U. S. NUCLEAR REGULATORY COMMISSION
OFFICE OF INSPECTION AND ENFORCEMENT
REGION IV

Report No. 80-16

Health Physics Appraisal Program

Facility Name: Fort Calhoun Station (FCS)

Figure 1
Ft. Calhoun Station Organization

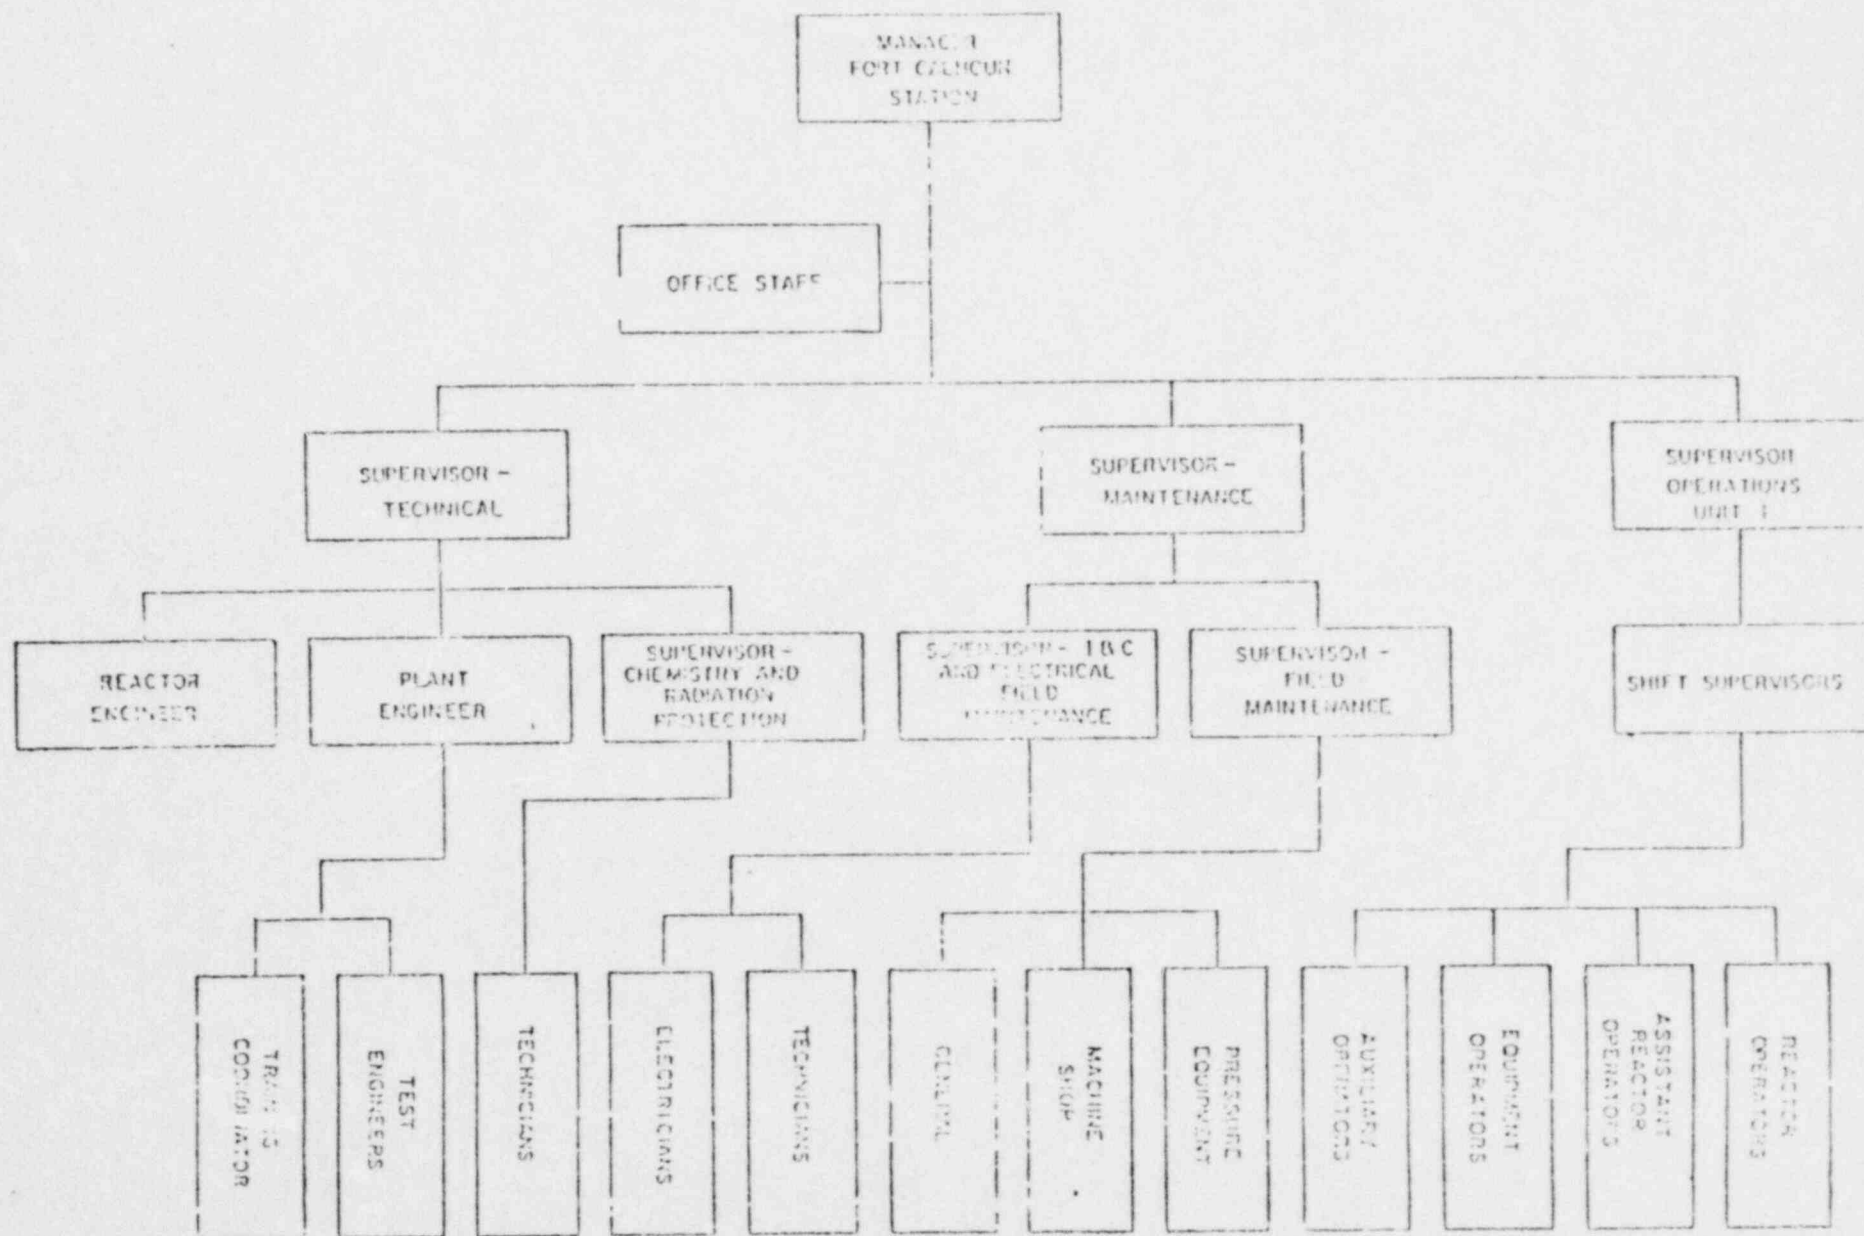
The Fort Calhoun Station (FCS) organization in place at the time of the appraisal is depicted by the chart in Figure 1. The organizational structure depicted is the same as that specified in Figure 5-2 of the FCS Technical Specifications. The radiation protection organization, shown in Figure 2., is directed by the Supervisor-Chemistry and Radiation Protection (Supervisor-C/RP) who reports administratively to the Supervisor-Technical. The Supervisor-Technical and the Supervisors of Maintenance and Operations are on the same organizational level and individually report to the Manager-FCS. The Supervisor-C/RP functions as the "Radiation Protection Manager" (RPM) as defined in NRC Regulatory Guide 1.8; however, there is no "RPM" job description or position title in the official organizational structure of FCS. Reporting to the Supervisor-C/RP are a Plant Chemist and Plant Health Physicist who supervise the daily activities in chemistry and health physics, respectively. The chemistry and health physics staffs consist of permanently assigned personnel as well as a pool of C/KP shift technicians who rotate between chemistry and health physics assignments. Omaha Public Power District (OPPD) does not have a radiation protection organization or individual at the corporate level but provides some radiological engineering, environmental monitoring and personnel dosimetry support through the Technical Services Section of the Production Operations Division.

The organization described above places the supervisor assigned the RPM responsibilities at a reporting level below that of operations and maintenance, and although FCS procedures state that the Supervisor-C/RP is responsible to the Manager-FCS for radiological health and safety, it appears to the Appraisal Team that this places an unwarranted administrative burden on the Supervisor-Technical as well as generating concerns about the RPM's independence and authority to administer the radiation protection program. Guidance on the placement of RPM functions in station organizations is contained in NRC Regulatory Guide 8.8, which recommends, in Section C.1.b.c., that "The Radiation Protection Manager (RPM) (onsite) has a safety-related function and responsibility to both employees and management that can best be fulfilled if the individual is independent of station divisions, such as operations, maintenance or technical support, whose prime responsibility is continuity or improvement of station operability." Therefore, the Appraisal Team feels that the organizational structure at FCS should be modified so that the individual designated as RPM reports directly to the Manager-FCS. Discussion of this matter with the Manager-FCS indicated that a revised Station organization has been proposed and is under review to elevate the Supervisor-C/RP (and RPM) position to the same reporting level as the Supervisors of Technical, Maintenance and Operations. The Appraisal Team considers this reorganization to be appropriate and supports this proposal.

1. The Station organization should place the Radiation Protection Manager function at the same reporting level as Operations, Maintenance and Technical.
2. The necessary steps should be taken to stabilize radiation protection staff turnover and increase the C/RP staffing level consistent with current plans under consideration.
